ADDENDUM NO. [1]

Date: March 26, 2018

**RE: WITC – SUPERIOR CAMPUS
PLUMBING AND HVAC MAINTENANCE
600 N 21ST STREET
SUPERIOR, WI 54880
HSR PROJECT NO. 17063-2 & 7**

**FROM: HSR Associates, Inc
100 Milwaukee Street
La Crosse, WI 54603
(608) 784-1830**

1 OVERALL FIRST FLOOR PLAN
1/16" = 1'-0"

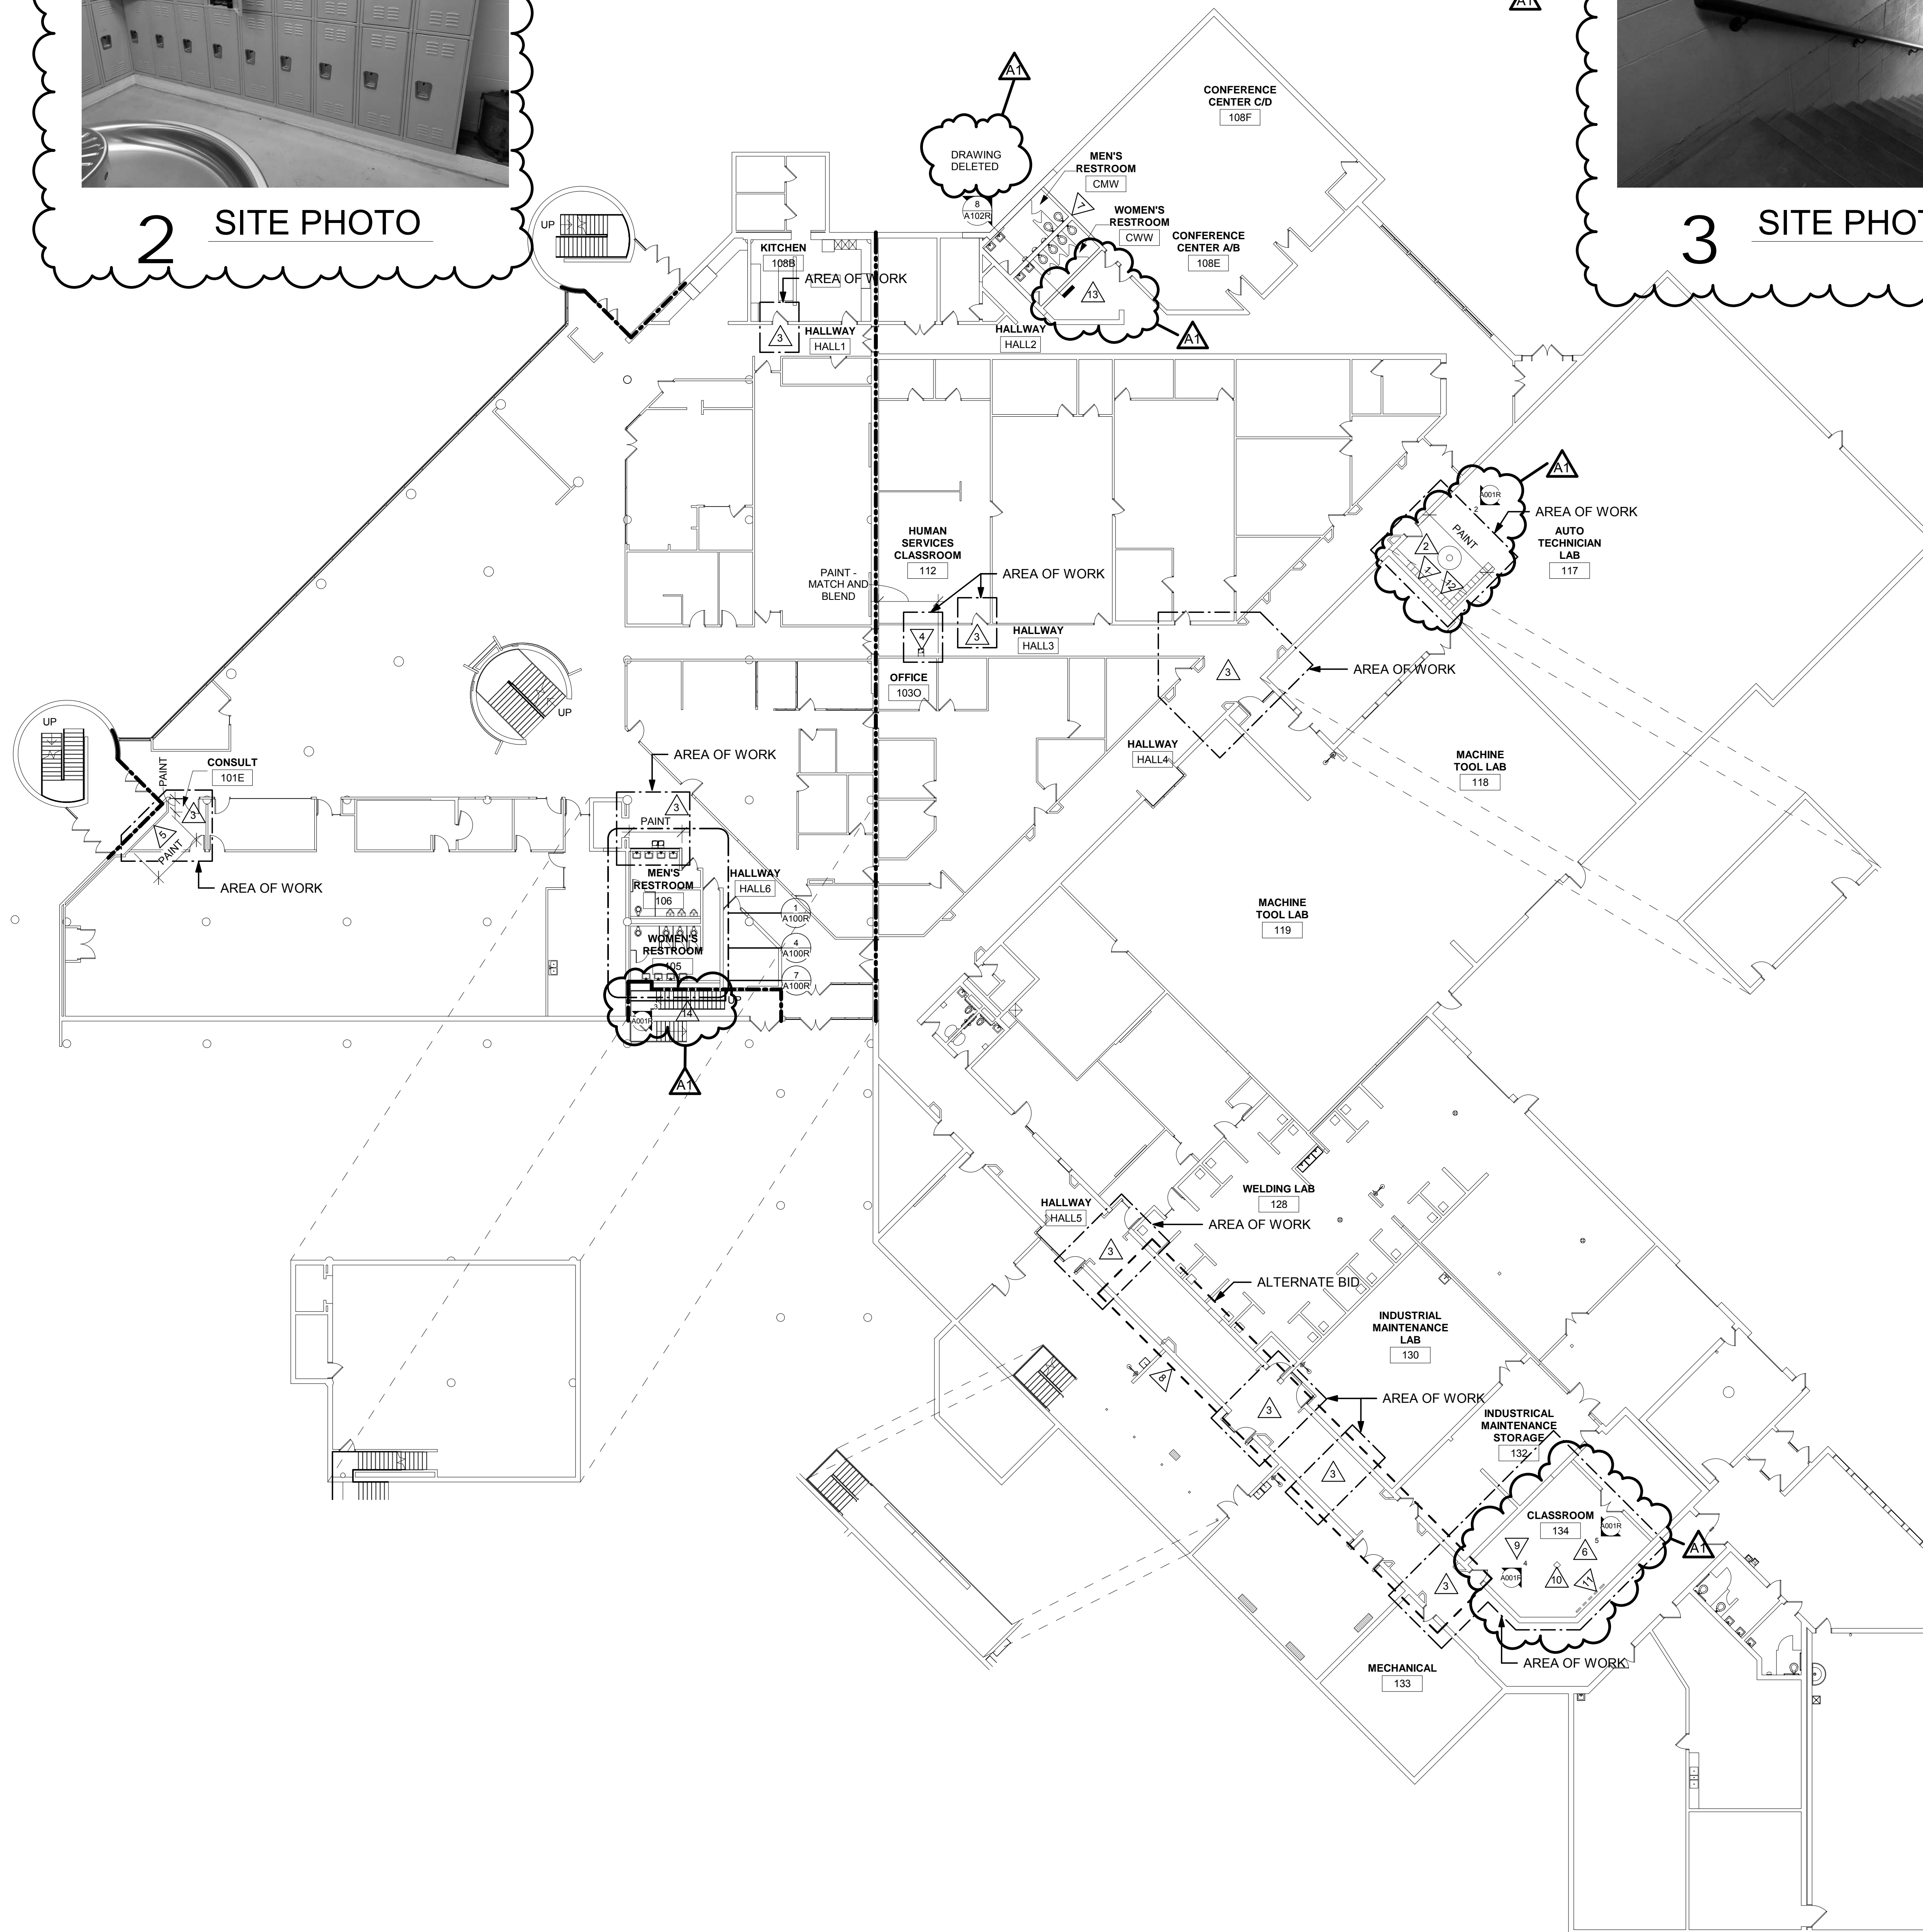
6. Sheet A001R FIRST FLOOR OVERALL PLAN 30 x 42 attached hereto
 - a. Revisions clouded on Drawing.
7. Sheet A002R SECOND FLOOR OVERALL PLAN 30 x 42 attached hereto
 - a. Revisions clouded on Drawing.

P113R

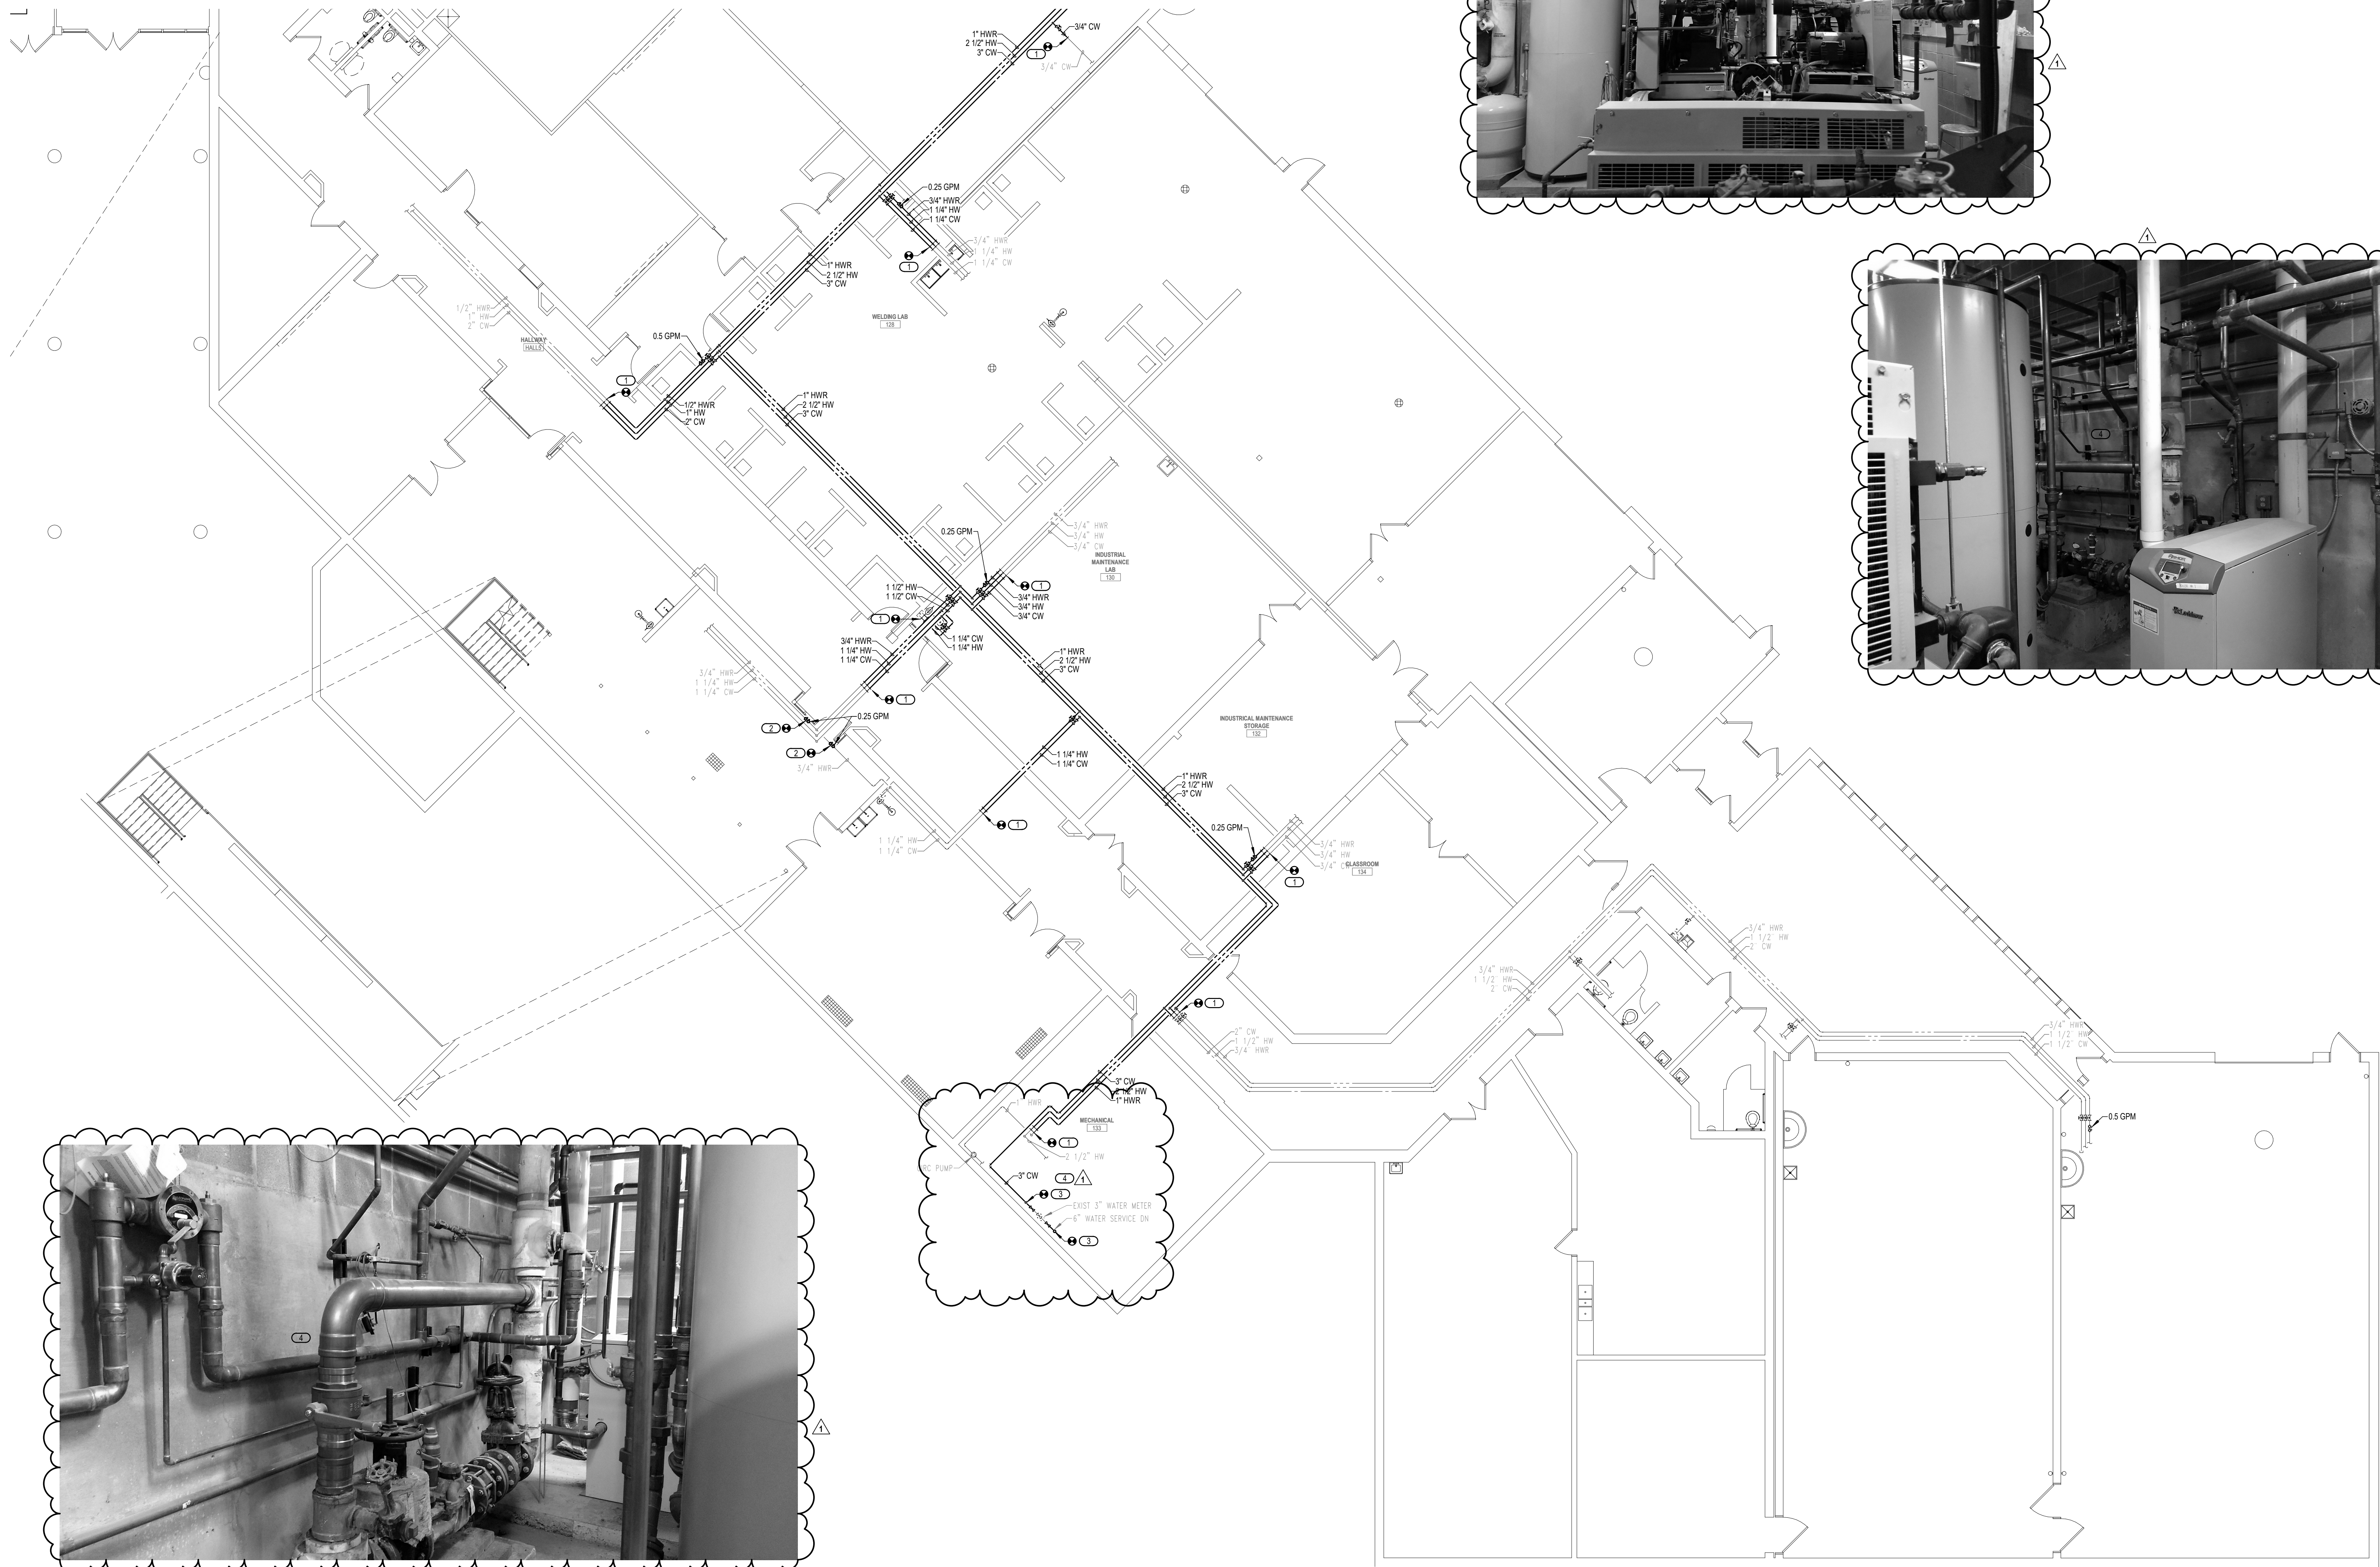
5. Section 01 23 00 ALTERNATES
 - a. Delete Alternate Bid No.4 – NOT USED
 - b. Add Alternate 5 as follows:
 - i. Alternate 5: Insulate Exposed Copper in Existing Boiler Room
The following work shall be priced under Alternate No. 5: State the amount to be added to the base bid to insulate all existing uninsulated domestic water piping in Mechanical Room 133. See pictures and notes at sheet P113R.

14. Sheet P113R FIRST FLOOR PLUMBING PLAN – AREA C 30 x 42 attached hereto
 - a. Revisions clouded on Drawing.
15. Sheet P121 SECOND FLOOR PLUMBING PLAN – AREA ‘A’
